Addendum 1  
to  
COIC Request for Quotes CET 21-14  
High Floor Dial A Ride Buses

January 5, 2022

To: ALL REGISTERED VENDORS AND TO WHOM IT MAY CONCERN  
From: Drew Orr, COIC Single Point of Contact  
RE: ADDENDUM 1

**CAMERA LAYOUT**  
(COVERAGE AND ANGLE)

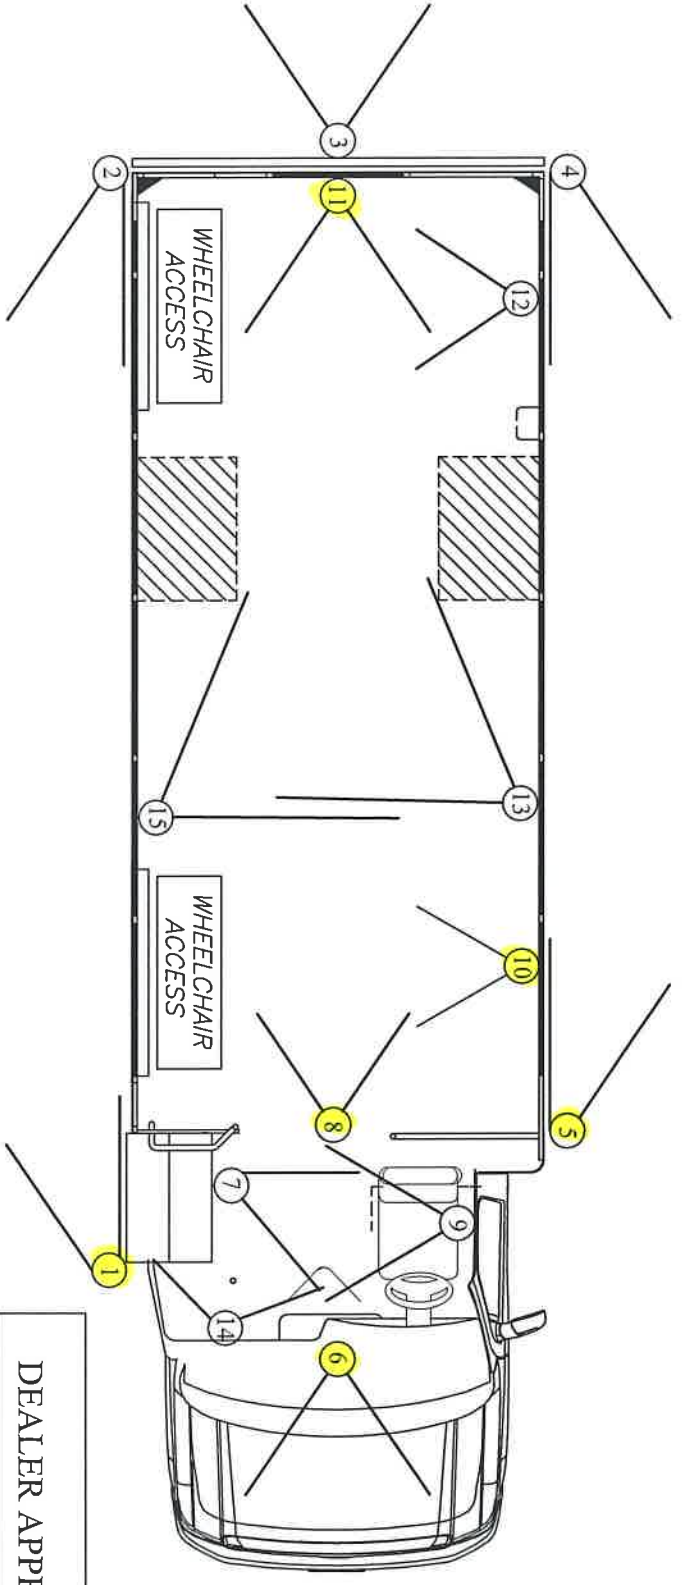
4	Our parts department is requesting camera locations to properly quote. Will you please mark on the attached proposed floorplan where you would like each camera to be located and note if the camera is interior or exterior.	Please see the attached illustration of where COIC would like for the cameras to be located. #1 and #5 are exterior. #6, 8, 10 and 11 are interior.

#	CAMERA	TYPE	LOCATION	VIEW	DEALER NOTES
1	710699	EXTERIOR	CURB SIDE FRONT <del>REAR</del> -FACING	CURB SIDE OF BUS	yes
2	710699	EXTERIOR	CURB SIDE REAR - FWD. FACING	CURB SIDE OF BUS	
3	710670	EXTERIOR	REAR VIEW	BEHIND BUS	
4	710699	EXTERIOR	DRIVER SIDE REAR - FWD. FACING	DR. SIDE OF BUS	
5	710699	EXTERIOR	DRIVER SIDE FRONT - REAR FACING	DR. SIDE OF BUS	yes
6	710680	INTERIOR	WINDSHIELD	ROAD	yes
7	710688	INTERIOR	ABOVE ENTRY DOOR	DRIVER	
8	710688	INTERIOR	FRONT - REAR FACING	FULL INTERIOR	yes
9	710688	INTERIOR	ABOVE DRIVER	ENTRY DOOR	
10	710688	INTERIOR	ACROSS FROM FRONT LIFT	FRONT LIFT	yes
11	710688	INTERIOR	REAR - FRONT FACING	FULL INTERIOR	yes
12	710688	INTERIOR	DRIVER SIDE REAR - FACING CURB SIDE	REAR PASSENGERS	
13	710699	EXTERIOR	MID BUS - DRIVER SIDE	MIDDLE /REAR PASSENGERS	
14	710675	INTERIOR	NEXT TO O.H. STORAGE COMPARTMENT	FULL INTERIOR /INCLUDING DR.	
15	710699	EXTERIOR	MID BUS - PASSENGER SIDE	MIDDLE /REAR PASSENGERS
